35/54-03C 8815 Hawkins Lane  
(Hawkins Lane Historic District)

**HISTORIC AREA WORK  
PERMIT**

SUBJECT: Historic Area Work Permit 35/54-03C

**HISTORIC PRESERVATION COMMISSION STAFF REPORT**

APPROVED  
Montgomery County  
Historic Preservation Commission  
*[Signature]* 5/28/03

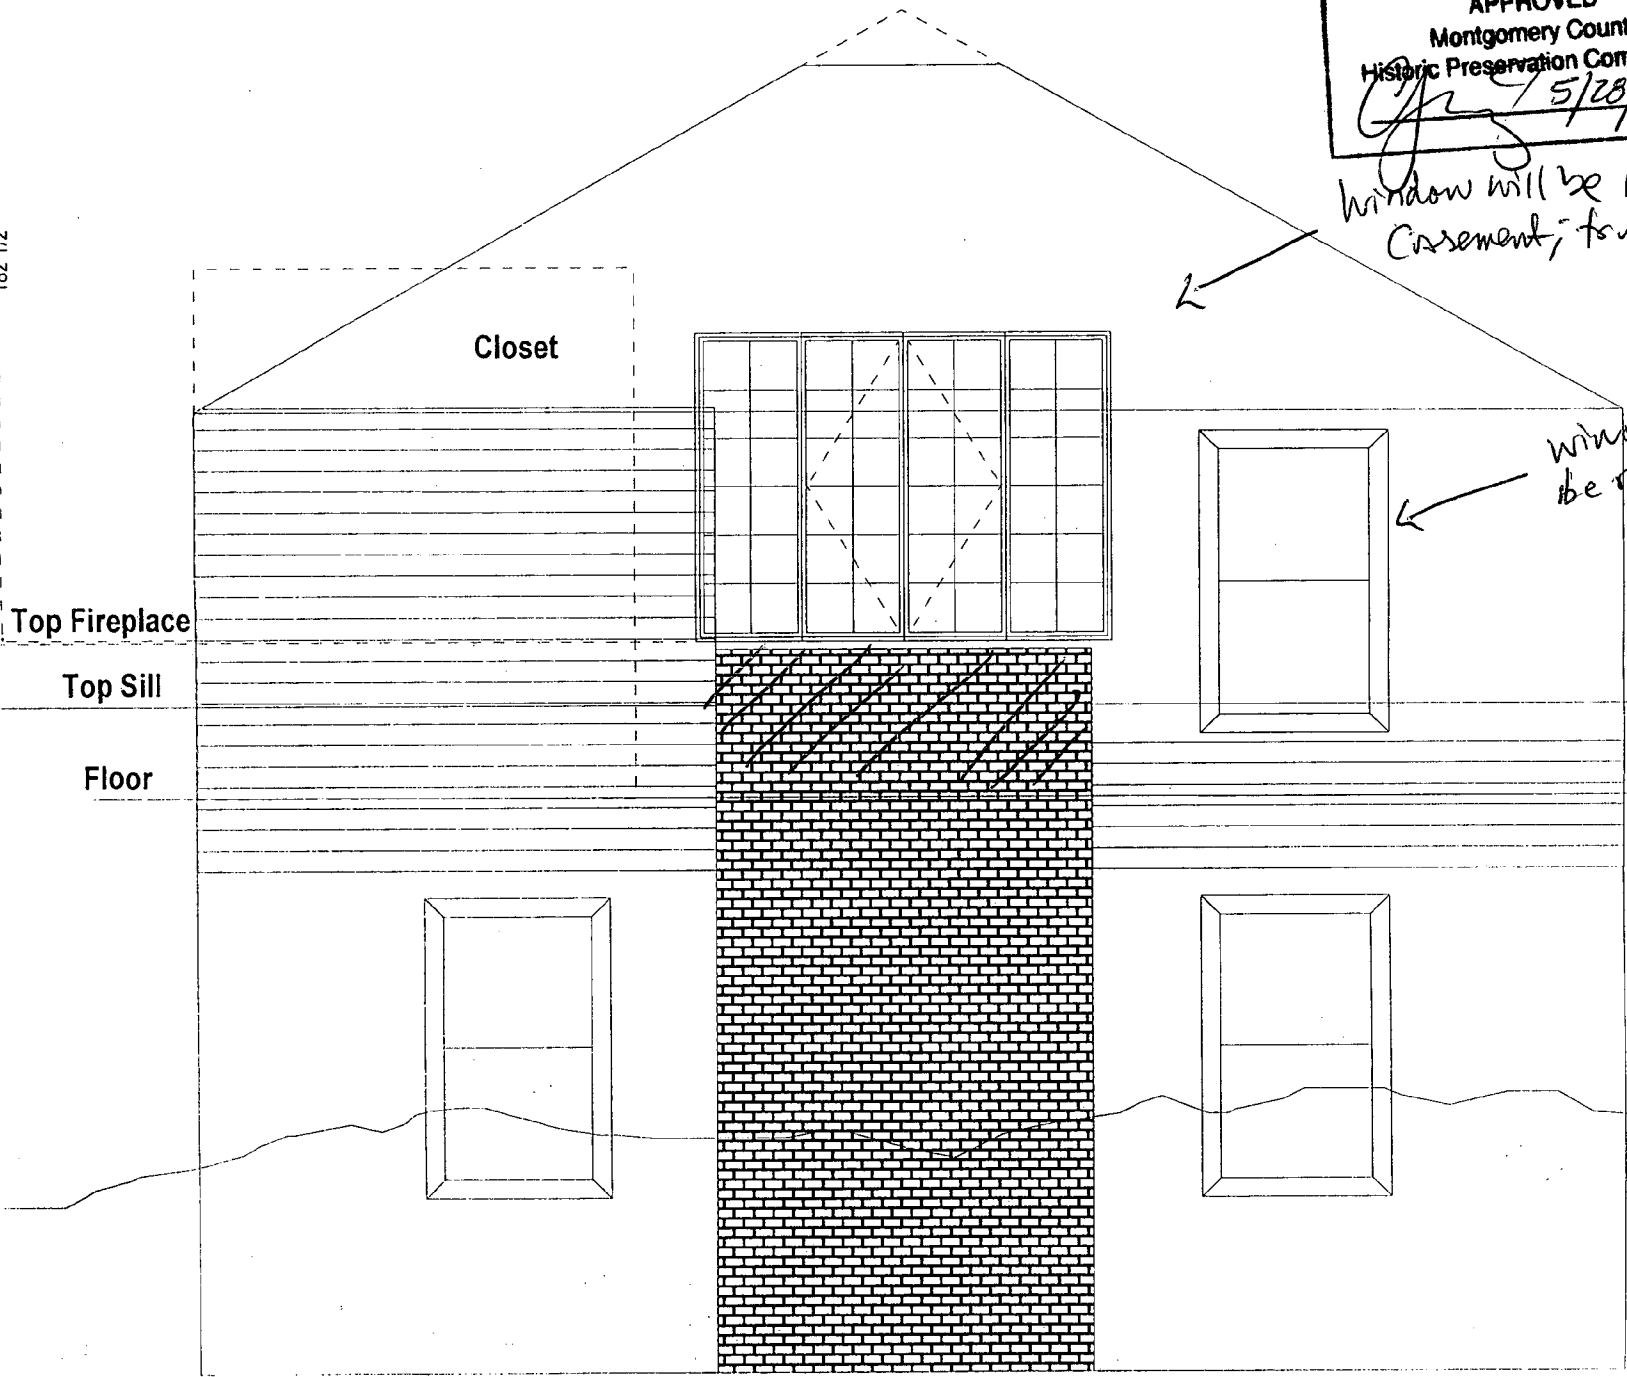
Window will be wood  
casement; true divided lite

Window to  
be removed as well

Note:  
Chimney will  
be removed  
from elevation

1. The entire chimney will be removed on the north elevation.

8815 Hawkins Lane  
 Chevy Chase, MD 20815  
 North Wall BR Elevation  
 1/4"=1'

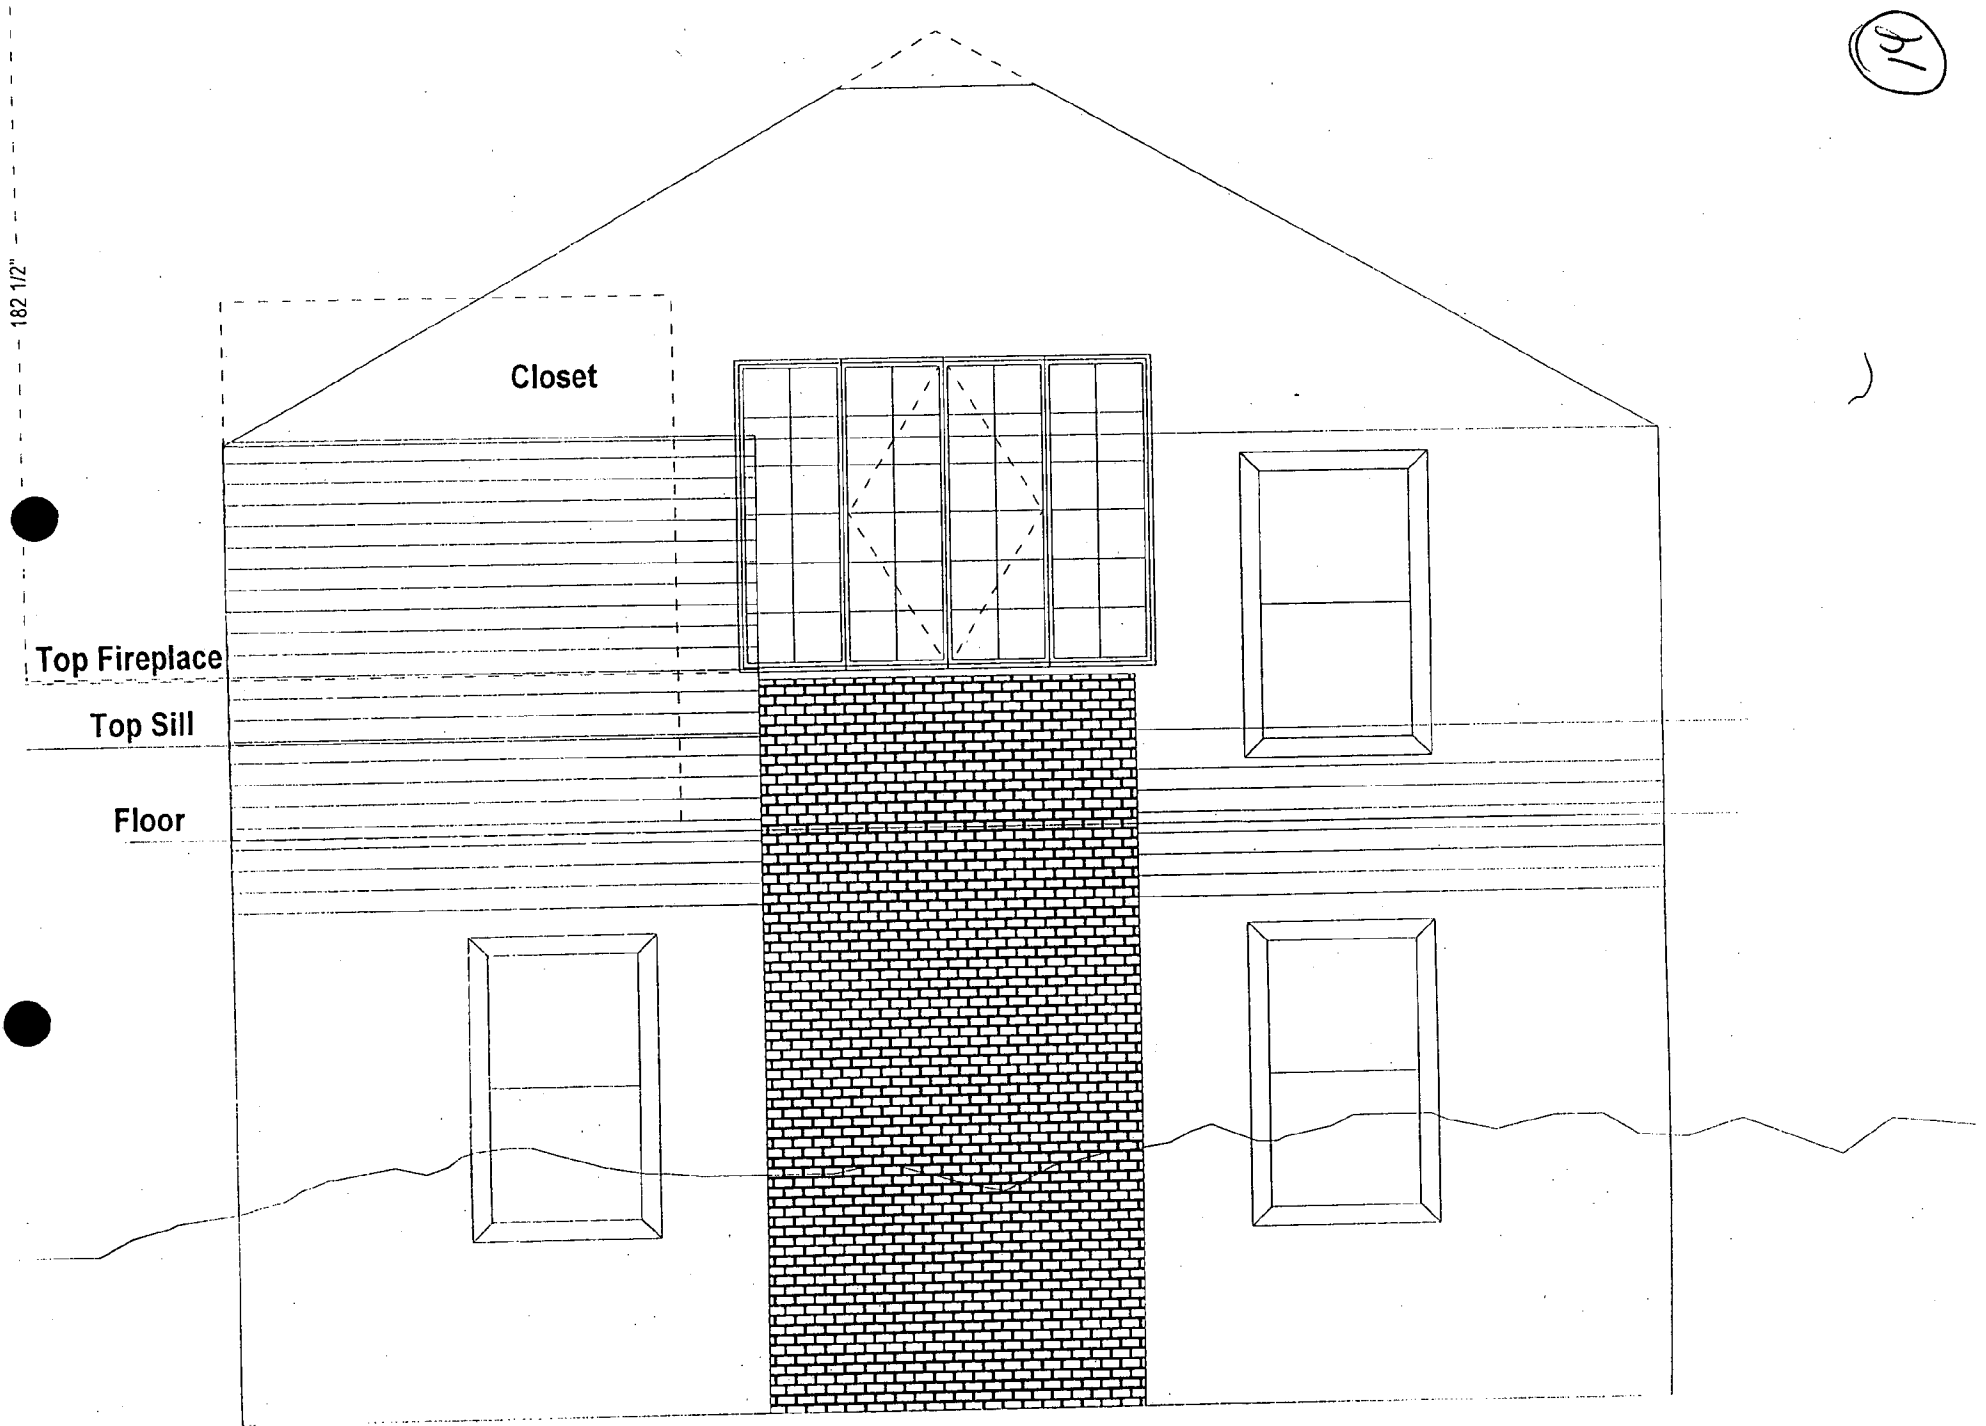
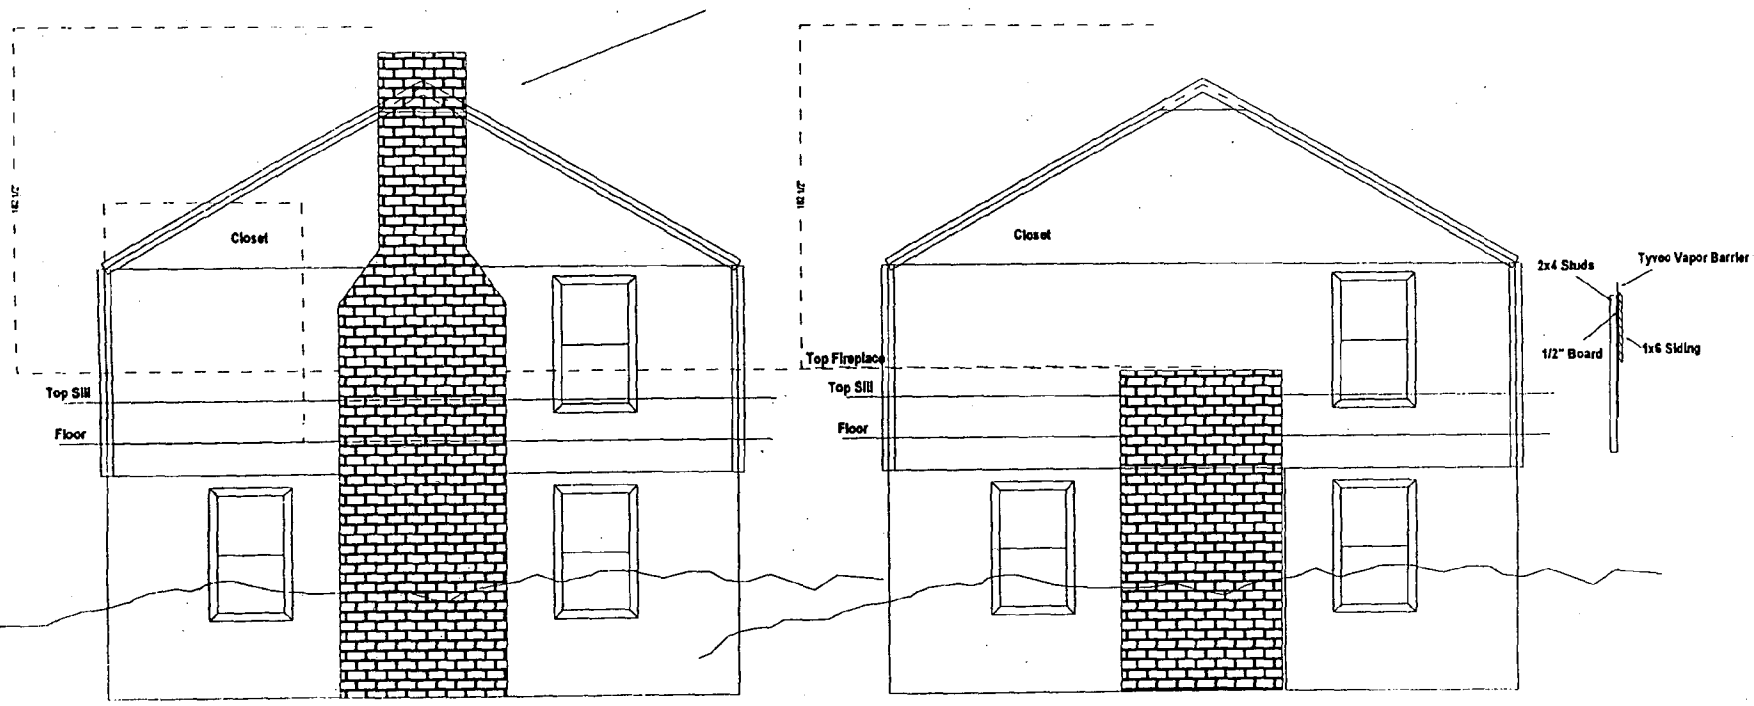
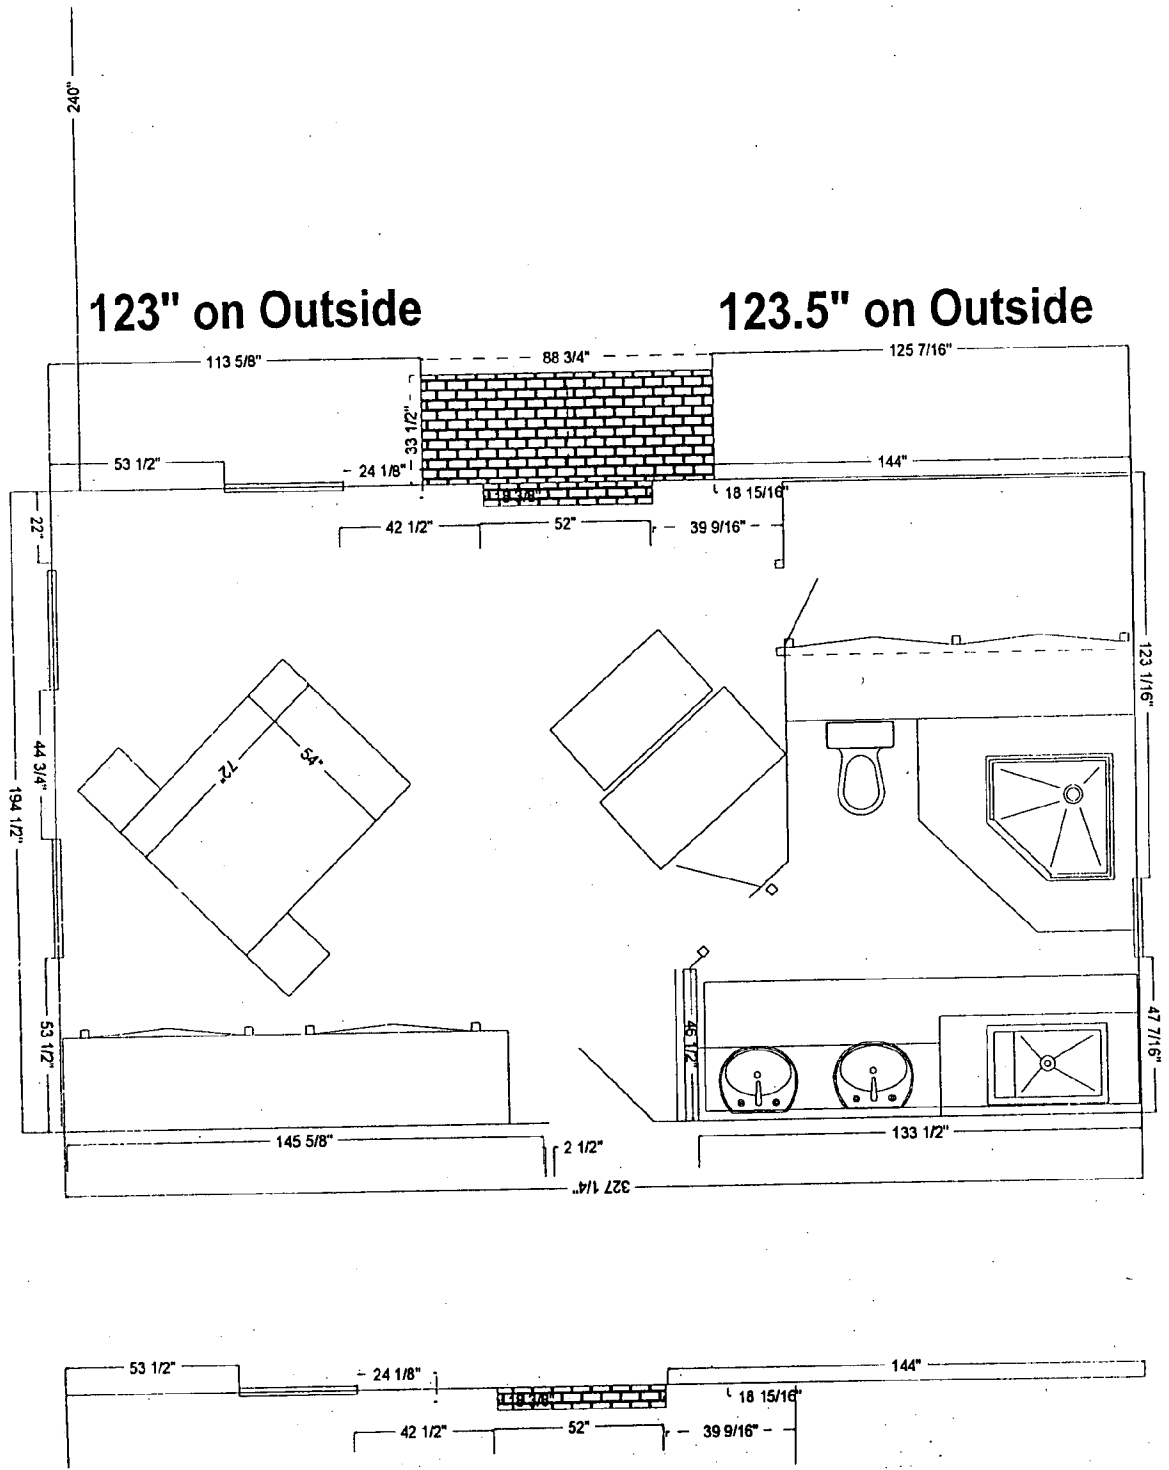
The applicant proposes to remove an existing chimney and 1/1 window on the north elevation in order to install a new window in its place, which is located on a 1997 addition. The applicant is going to install a wood true-divided window with four vertical casements on this north facing elevation that will have a poly baked-on wood finish. Half of the chimney will remain on this elevation underneath the proposed window.

Staff recommends approval of the project overall as an alteration to a new 1997 addition. The removal of half of the chimney and a 1/1 double hung window is also fine

with staff. In addition, the proposed window is acceptable as a wood true-divided lite casement window, which is in keeping with historic materials pre-approved by the Historic Preservation Commission for the Hawkins Lane Historic District.

Remove Top of Chimney
